Job Number: 230021
Date: 16 May 2024

Re: Flood Advice for a State Significant Development Proposal BaptistCare Carlingford- Seniors Housing – Stage 2 Review

GRC Hydro (GRC) has been engaged by the NSW Department of Planning, Housing and Infrastructure to review the flood-related components of the development submission.

Figure 1: Post-Development Peak Flood Level Afflux

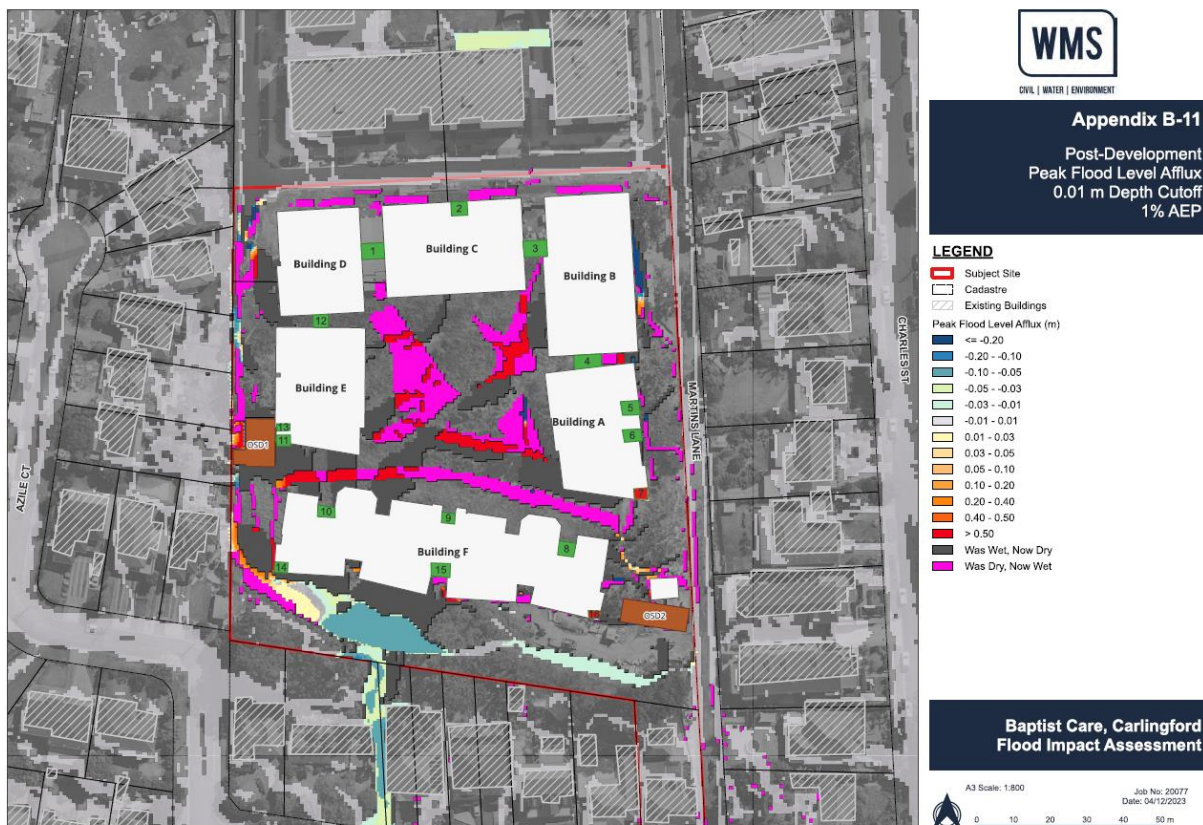
The proposed development's impact on local flood affection in the 1% AEP event is documented in Appendix B-11 of the FIA. Flood levels under the existing case experience some small increases in the middle of the site and inside its western boundary, however in the south of the site, and in the adjacent properties south of the site, the flood level decreases relative to the existing case. There are a small number of random cells south-east of the site that show as "Was Dry, Now Wet" but these appear to be characteristic of some minor model instability so in reality, this area is unlikely to be affected by the proposed development.
